Planning Commission Staff Report

MAPLETON

Consideration of a request to rezone 13.5 acres from A-2 to RA-1 with a TDR-R and a preliminary plat application for 13 lots located at approximately 1200 West and 400 South.

Development Review Committee Minutes

LARSEN SUBDIVISION PLAT "A"

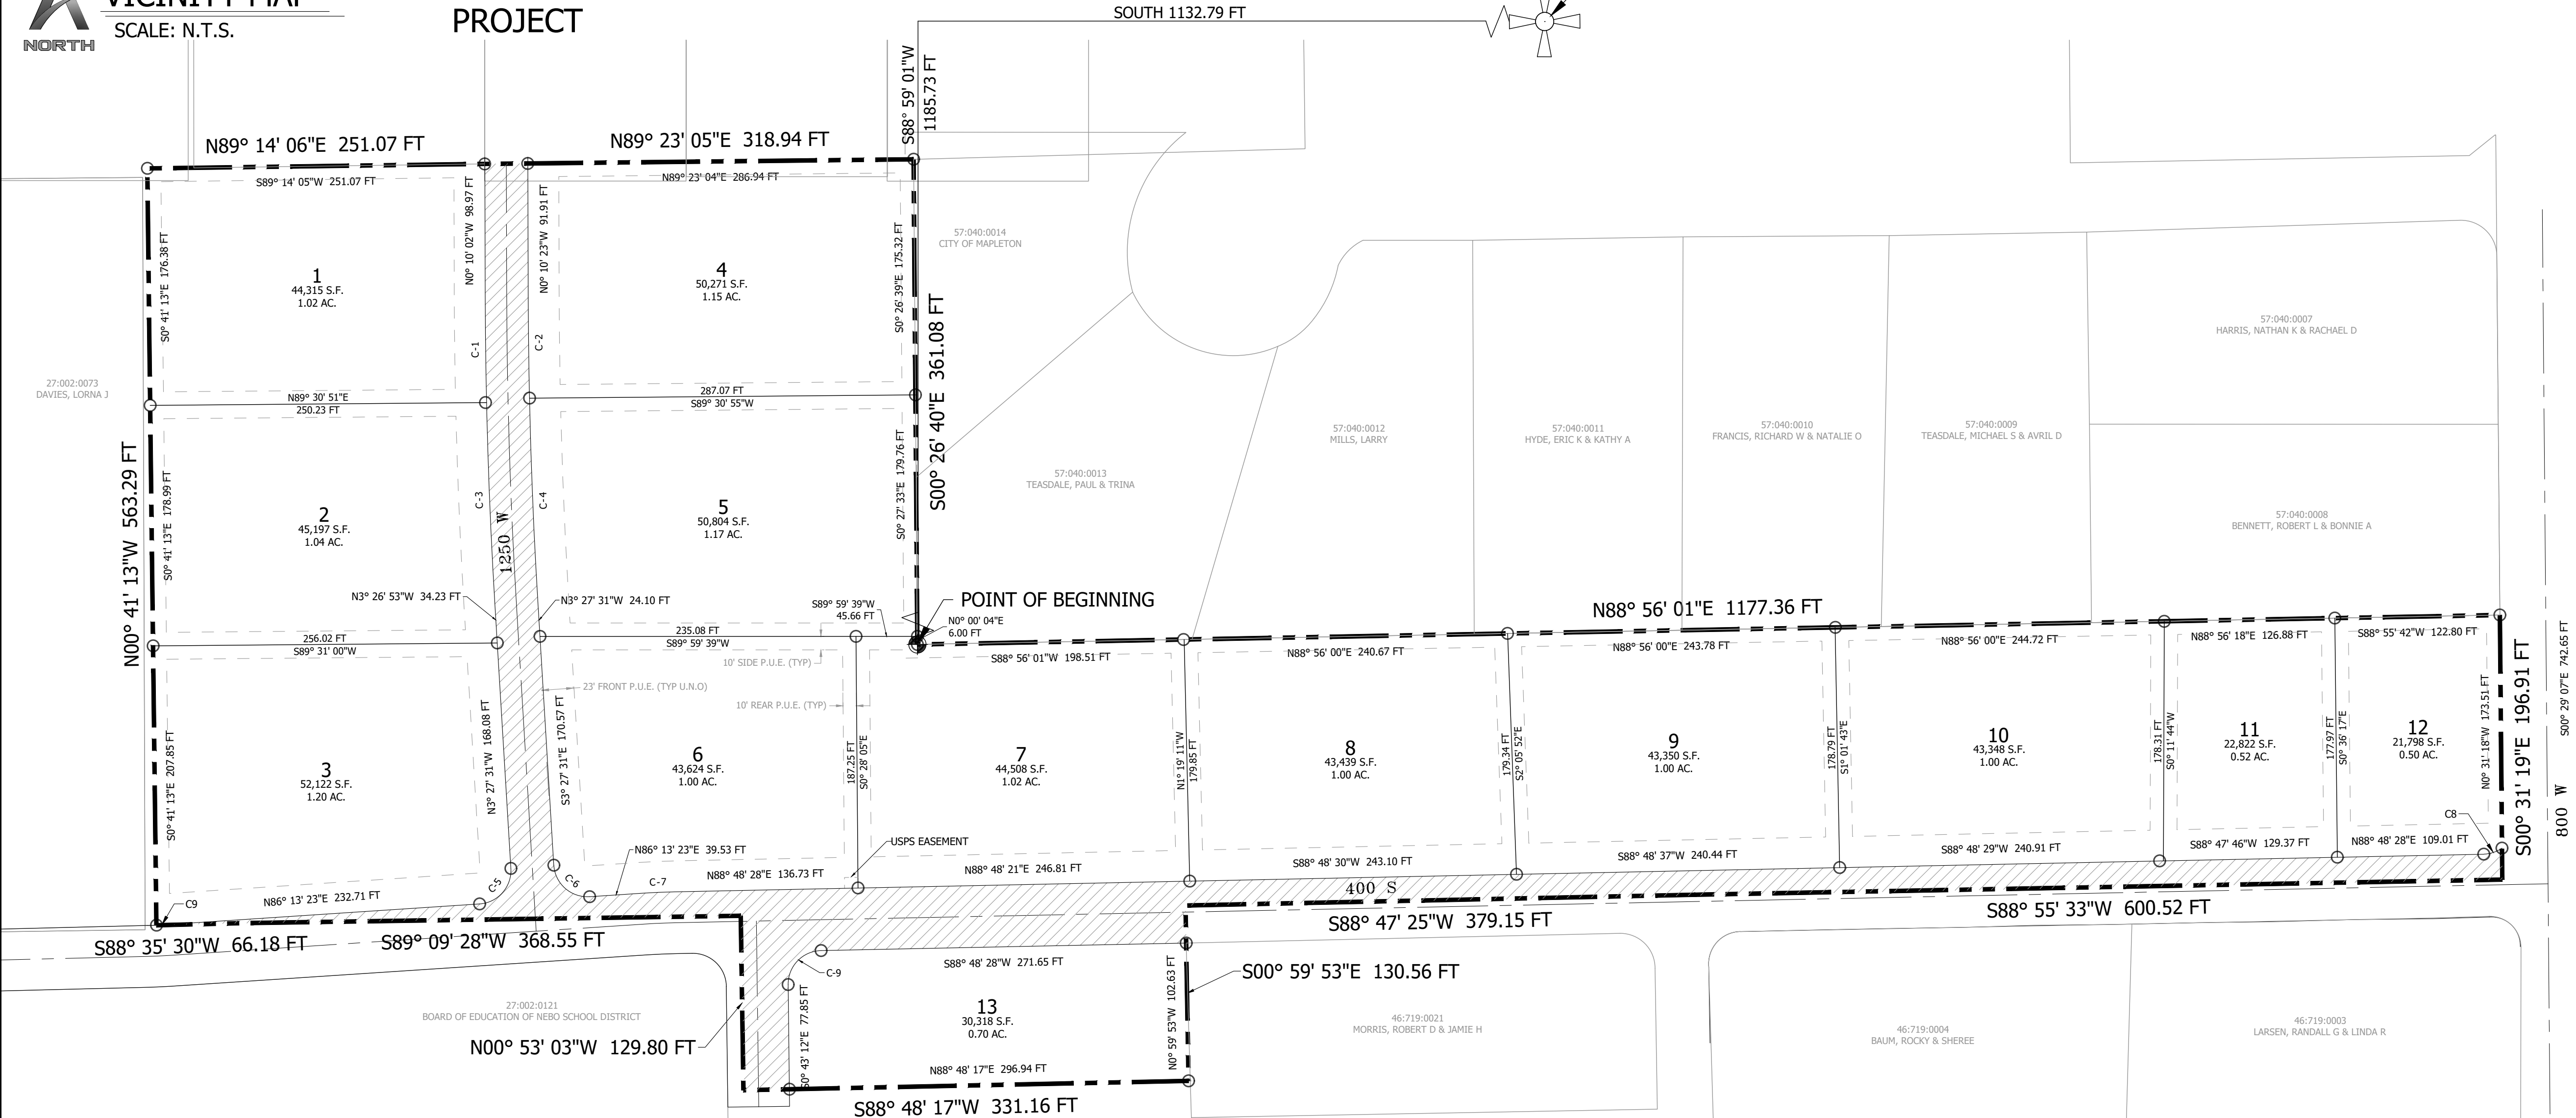
1. The application will require approval of a Rezone to RA-1 with a TDR-R and the use of one TDR certificate.
2. Please note on the plat that lots 3 and 6 must get their primary access from 1250 W not 400 N.
3. Include the attached addresses on the plat.
4. Add a signature line for the Community Development Director under Planning Commission approval and remove the signature lines for the City Attorney and County Recorder under Legislative Body. Also, remove the Utah County Recorder signature block section.
5. A temporary turnaround meeting fire department requirements must be included at the north end of 1250 W.
6. Mailbox cluster may not be located on 400 South
7. A reimbursement payment of \$112,541 is due to Nebo School District.

Please ensure 10' separation between culinary water and sanitary sewer lines.

A note must be placed on the plans to identify any existing fences and/or improvements on adjacent properties. If construction requires the removal of or results in damage to these items, they must be replaced before the final development inspection can be completed.
